**CABINET MEMBER FOR HIGHWAY MANAGEMENT – 26 JANUARY
2023
YARNTON: CASSINGTON ROAD - PROPOSED RAISED PARALLEL
CROSSING**

Report by Corporate Director, Environment and Place

**CASSINGTON ROUNDABOUT
CROSSING**

Drawing Number		Status	Rev
5101182-MIL-HGN-1A-DR-CH-0111		S2	P02

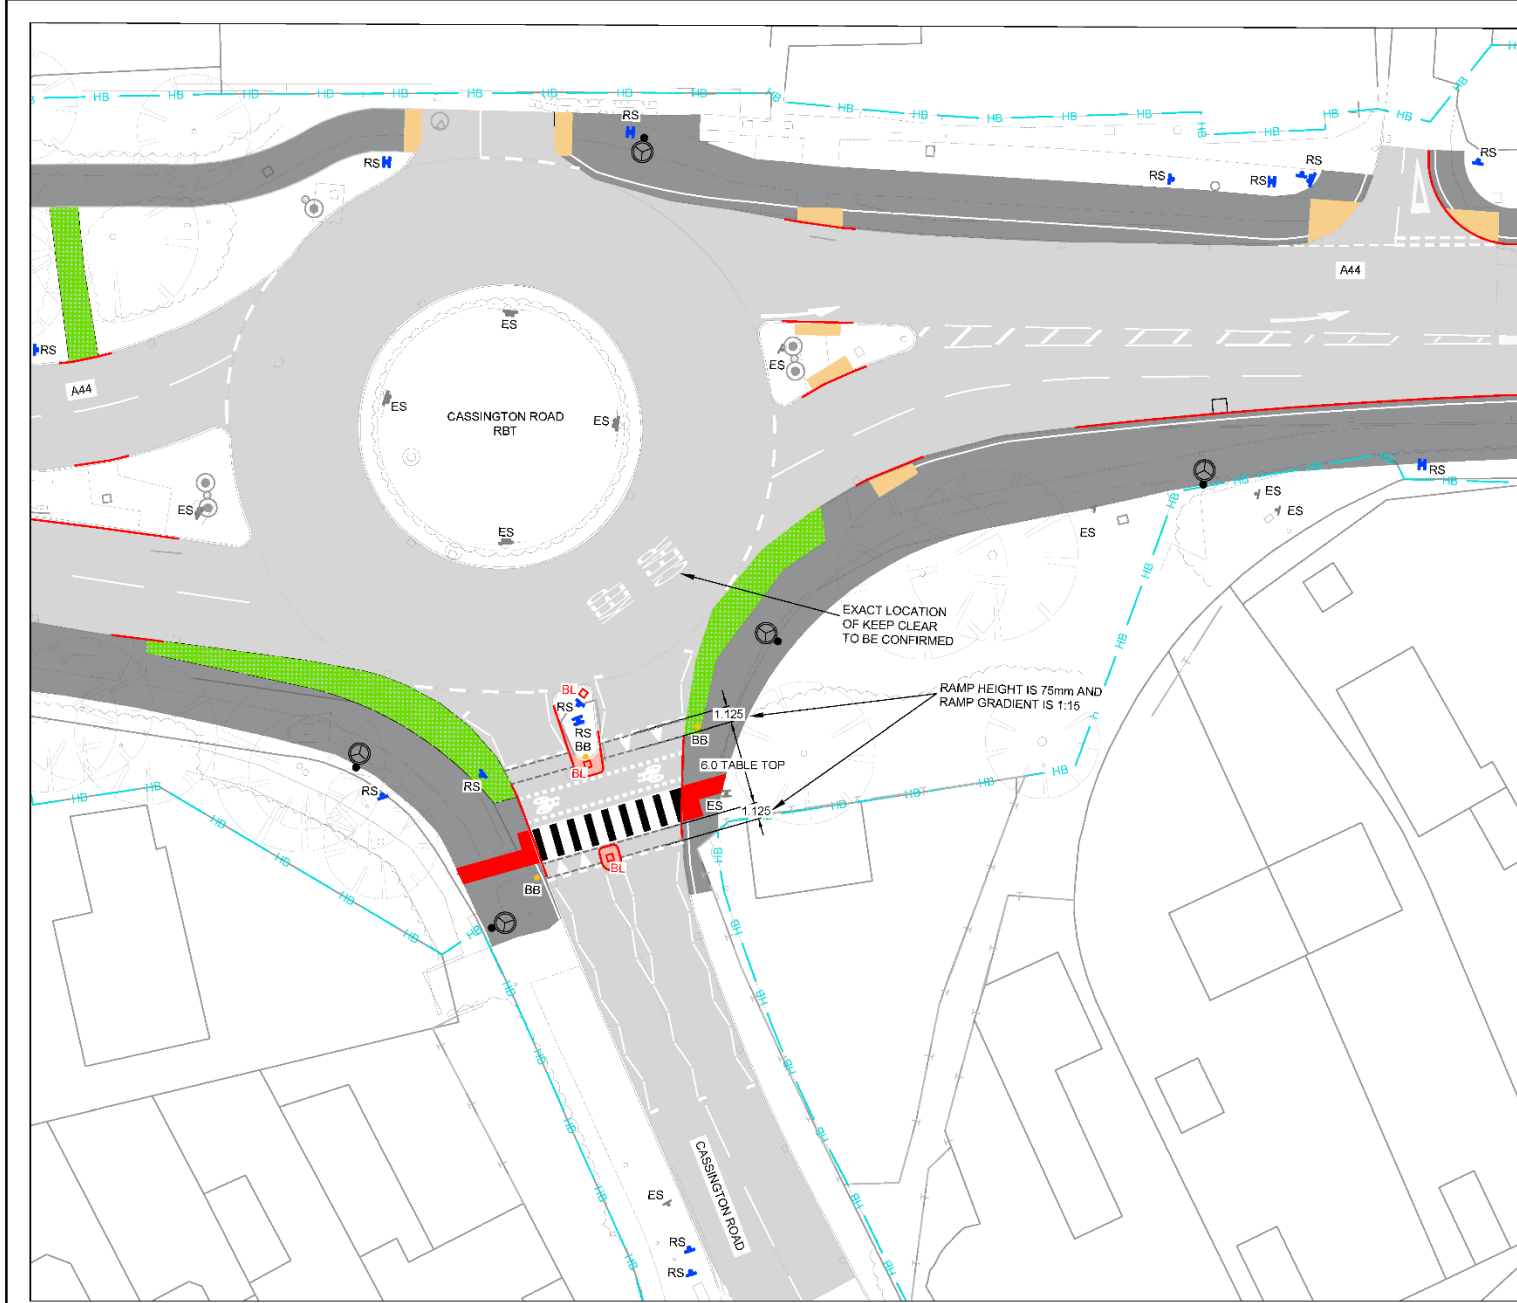
RESPONDENT	COMMENTS
(1) Traffic Management Officer, (Thames Valley Police)	<p>No objection – In principle I do not object, but do have concerns.</p> <p>Turning left from the A44 into Cassington Road inter-visibility is severely restricted by the hedge line. The crossing although it may be on the current desire line seems very close to the roundabout</p> <p>Does the crossing meet all current design requirements and will it be subject of a Safety Audit. The necessary speed monitor has or will take place.</p>

(2) Local County Cllr, (Kidlington South division)	<p>Concerns – I'm concerned that the crossing is uncontrolled and so close to a busy junction from a fast flowing road. Whilst I appreciate that the proposal includes some measures to slow traffic down by means of a raised cushion, this doesn't really provide the kind of positive pro-active protection that I would prefer to see.</p> <p>Traffic from the A44 can exit the roundabout at some speed at this point which could then bring it into conflict with pedestrians half way across the crossing. Sight lines are also not good at this point which would make the situation worse.</p> <p>Whilst moving the crossing further down the Cassington Road would seem like a more sensible option, we then have the problem of desire lines both for pedestrians and cyclists. This could lead to those users crossing closer to the junction anyway which would negate the point of the crossing.</p> <p>So my suggestion would be to make this a lights-controlled crossing with modifications to the junction to enable traffic exiting the A44 to see well in advance that the lights are against them. There may also need to be further advanced warning on the A44 to prevent a build up of traffic prior to the roundabout or at least to allow that build up to be navigated safely.</p> <p>I am hopeful that a site meeting planned with officers, myself and parish councillors may inform a more practical solution to all these points.</p>

<p>(3) Yarnton Parish Council</p>	<p>Object – A safe formal crossing point at the Cassington Road roundabout is necessary and would be welcome. The visual splay at the proposed position is limited and presents difficult lines of sight. Despite different road users priorities being assigned within the Highway Code the planned position of the crossing allows little opportunity for vehicle drivers, (particularly those unfamiliar with the area, layout and/or immediacy of a crossing point so close to the roundabout) to react in the event of appropriate or inappropriate action of crossing users.</p> <p>Yarnton Parish Council recommends that the crossing be positioned further west in Cassington Road (past the access driveway to 2 Woodstock Road). In addition, between Great Close Road and the Cassington Road roundabout the road should be slightly widened to allow a central island to be constructed and a staggered crossing (similar to the south side of the A44 opposite The Turnpike PH) installed. Physical barriers should be installed to ensure pedestrian and cycle crossing is possible only at the designated crossing.</p> <p>Alternatively in the safe interest of the most vulnerable road users the crossing must be traffic light controlled.</p>

<p>(4) Shipton-on-Cherwell and Thrupp Parish Council</p>	<p>Concerns – the Parish Council consider that this is MUCH too close to the roundabout. Maybe 20 meters further down Cassington Road would be preferable.</p> <p>The reason for this is that if more than one car is turning into Cassington Road, and has to stop for pedestrians/cyclists/low-flying aircraft; then it will potentially block the roundabout, and cause a further unnecessary hazard.</p>
<p>(5) Cherwell District Council, (Development Management)</p>	<p>No objection – Cherwell District Council wish to make no observations with regard to the proposal.</p>
<p>(6) Member of public, (Yarnton, Bernard Close)</p>	<p>Concerns – I fail to see the need to raise the carriageway as the footpaths either side are currently ramped down level with the road surface. Rainwater currently drains away quite successfully, and I fear this may not happen during heavy rain if the carriageway is 'humped', resulting in vehicles inadvertently splashing extra rainwater onto the footpath. There is also the unnecessary cost of installing and maintaining said hump.</p>

Support – This is one of the biggest hazards in the A44 cycle route from NCN5 or the Oxford canal route to Blenheim Palace, Woodstock, Hanborough or points West. It is highly nerve-wracking to cross when a car may swing in at high speed.

The design improves this substantially on the current situation.

Reducing the speed of exit traffic remains a priority. We support the use of a raised table for the crossing, but we are aware of a high collision rate on left turns in a similar situation on the Wooton Road roundabout to the north of Abingdon (on the roundabout rather than on a crossing). There, the south-east verge was built-out significantly to reduce the speed of left turns off the ring road, and this does seem to have reduced speeds although it is too early to tell the impact on collisions. A similar solution could be used here.

10. In response to queries raised by Thames Valley Police, the location meets with desire lines of both pedestrians and cyclists and has been subjected to both Stage 1 and 2 Road Safety Audits. In addition, the crossing has been submitted to the Department for Transport for consideration and authorisation for it's use in this location had been granted. The design also includes a reduction of the speed limit to 40mph on the A44 and this will continue to be monitored.

11. Following the objection to the proposals from Yarnton Parish Council and the concerns of the local County Councillor (Kidlington south) a site meeting was held on 7th December to discuss concerns. At the meeting, reasons behind proposing this crossing type were summarised including hierarchy of users, desire lines, minimising wait times for pedestrian and cyclists plus less impact on traffic flows if the crossing was fully signalised. As mentioned in point 9 above, officers informed that the permanent speed limit is also being reduced and the crossing has been subjected to Road Safety Audits. The crossing type and it's location has also received authorisation from the Department for Transport.

- 11 Concerns raised in other responses were with regards to drainage at the road hump location and vehicles backing up through the roundabout when the crossing is in use. Officers confirm that the existing drainage has been surveyed across the whole site of proposed work including at the new raised crossing point and an additional two number new gullies have been included in order to cater for surface water run – off in this location and that the design includes for a ‘KEEP CLEAR’ road marking on the circulatory carriageway to roundabout to help maintain traffic flow at all times.
- 12 The expression of support was received from the Oxfordshire Cycling Network, who acknowledged the location as one of the biggest hazards in the A44 cycle route from NCN5/the Oxford canal route to Blenheim Palace/Woodstock/Hanborough or points further west.
